TE Connectivity

Product Change Notification: P-24-026946

Sliver straddle mount connector

Description of Changes

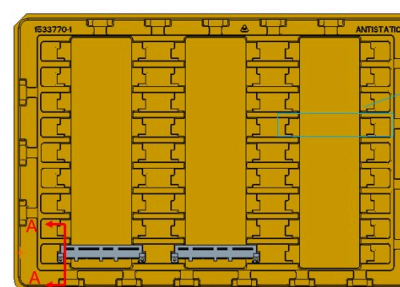
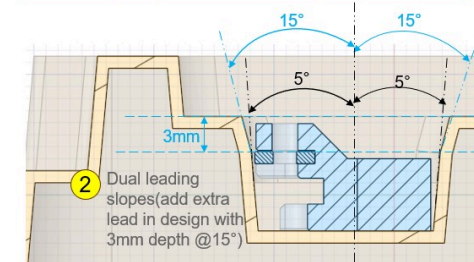
1.Cancel extra fixation flange at bottom of tray; 2.Change leading design from single slope to dual slope by adding extra leading in design.

Product improvement.Aimed to ensure connector sliding down to tray pocket much more smoothly
